**Vogtle Project**

NRC DOCKET NUMBERS 50-424 AND 50-425  
CONSTRUCTION PERMIT NUMBERS CPPR-108 AND CPPR-109  
VOGTLE ELECTRIC GENERATING PLANT - UNITS 1 AND 2  
REQUET FOR SUPPLEMENTAL INFORMATION  
DSER OPEN ITEM 34 - STEAMLINE BREAK DNBR

RESPONSE TO REQUEST FOR ADDITIONAL INFORMATION  
WCAP 9226 (P) 19227 (NP)

### QUESTION ON GENERIC STEAMLINE-BREAK TOPICAL REPORT (WCAP-9226)

Figure 14.2-11

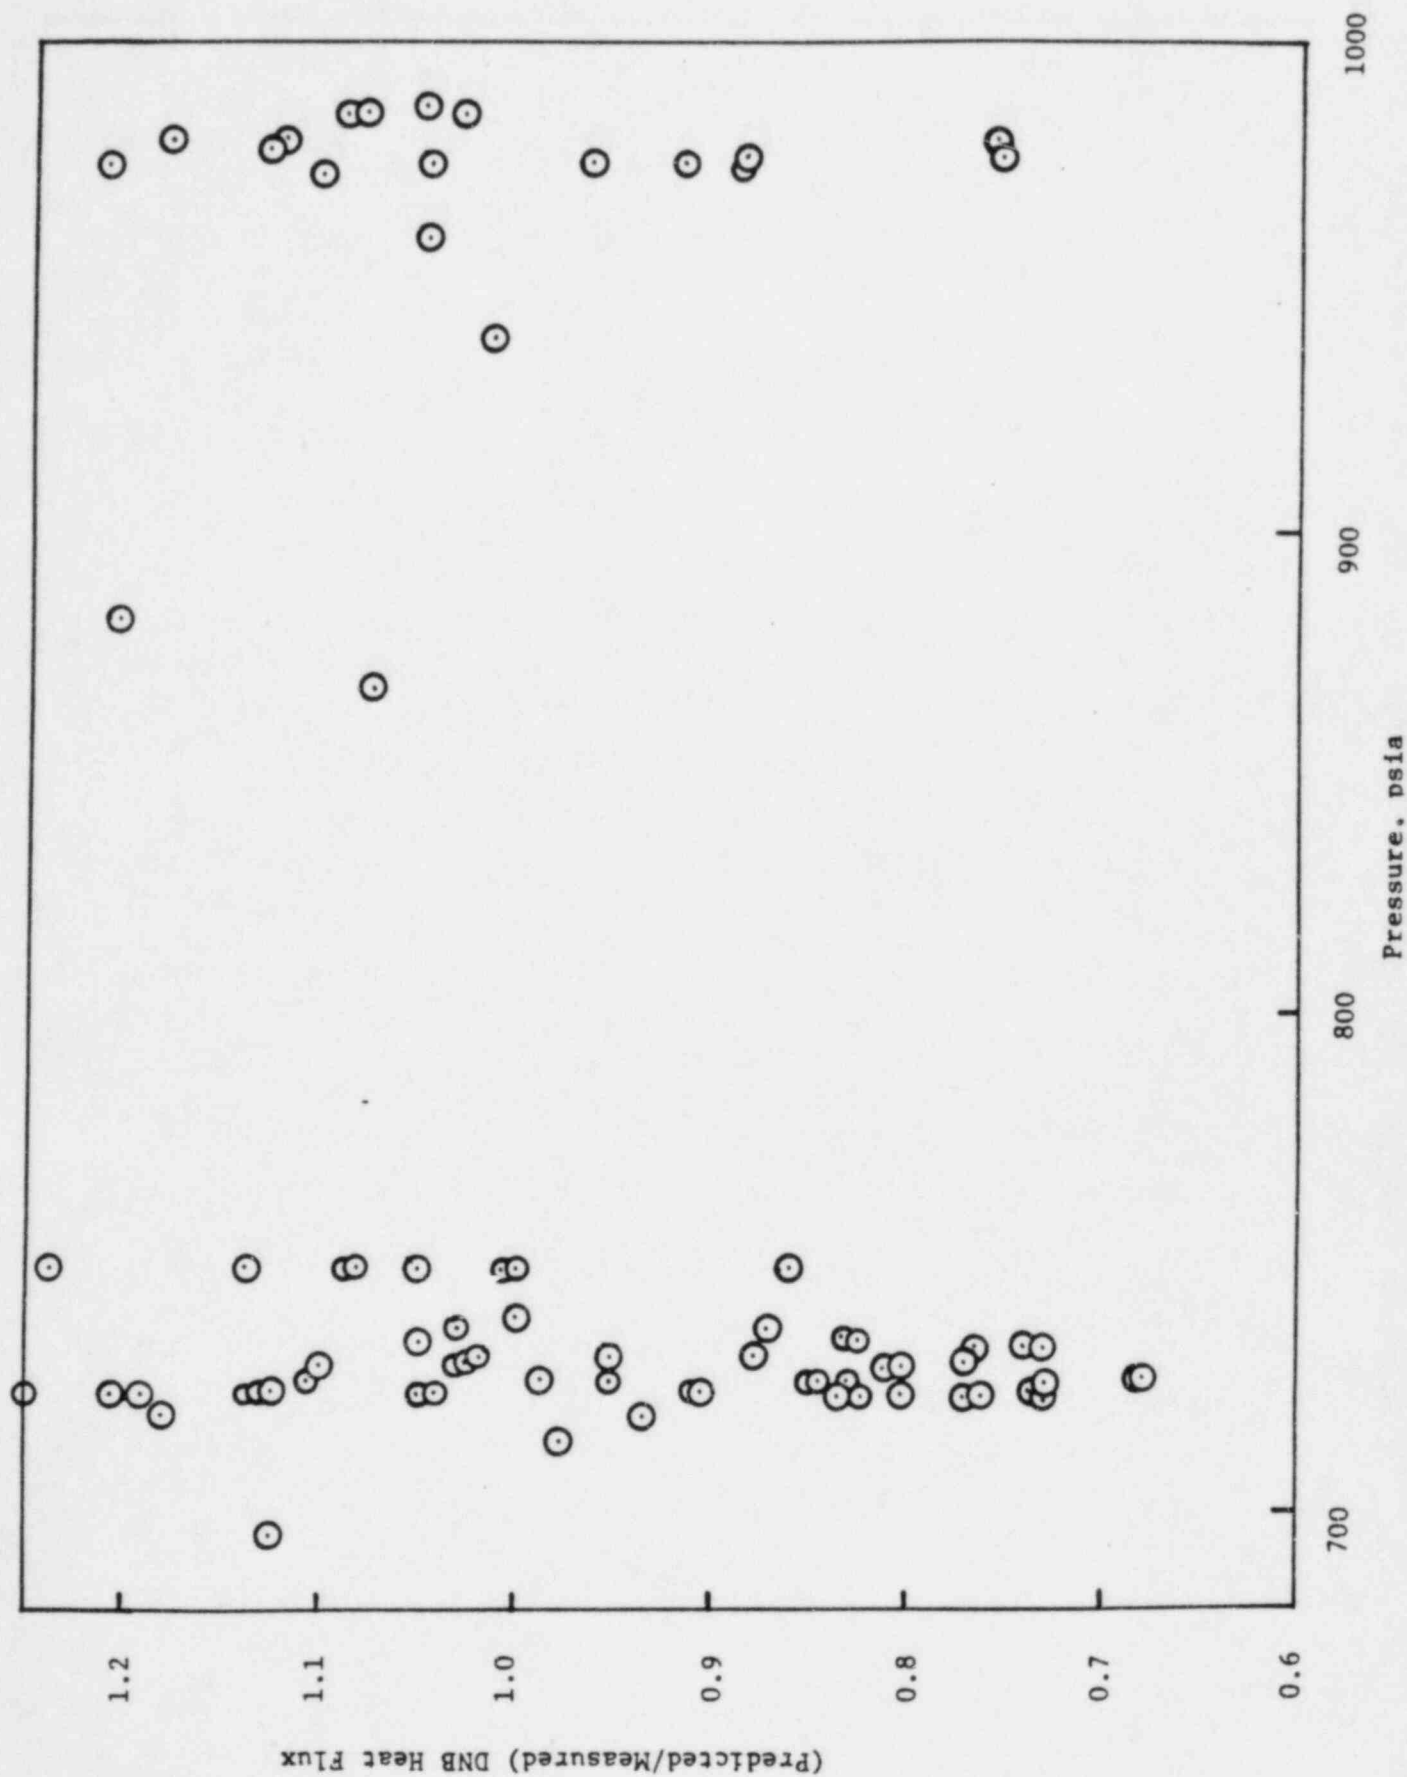
In a letter from T. M. Anderson to J. Stolz, dated May 7, 1979, Westinghouse responded to NRC's questions relating to WCAP-9226. Question 222.9 requested references for the W-3 correlation which cover the applicable range of the calculated coolant parameters.

We have reviewed those references and find them incomplete for the range of coolant parameters calculated in WCAP-9226. The references limit the applicability of the W-3 correlation down to 1000 psia. Steamline break analyses, calculated by Westinghouse, have shown decrease in primary system pressure to the range of 500 psia. Provide additional justification for the applicability of the W-3 correlation below 1000 psia. What is the minimum pressure for which the W-3 correlation and corresponding 1.3 minimum DNBR limit can be used?

Reference 2 contains the results of an analysis of low pressure (700 - 1000 psia) data using the W-3 correlation. Those data were taken from the same sources as those used in the development of the W-3 correlation. As shown in the attached figure (taken from Reference 2), no anomalous behavior is observed for the low pressure data.

The W-3 correlation statistics have been recalculated for the extended database (P = 700 - 2300 psia). The revised statistics are essentially unchanged from the original values (Table 1). The limit DNBR was also recalculated using the method of Owen (Reference 3.) As shown in Table 1, the revised correlation statistics demonstrate that there is a 95% probability with 95% confidence that DNB will not occur if the minimum DNBR is maintained in excess of 1.31. Again, this value is essentially unchanged from the limit DNBR associated with the original database.

This evaluation demonstrates that extending the pressure range of the W-3 correlation database by a significant amount has a negligible effect on the correlation statistics. Therefore, continued use of the 1.3 limit DNBR for steambreak analyses of Westinghouse pressurized water reactors is justified.
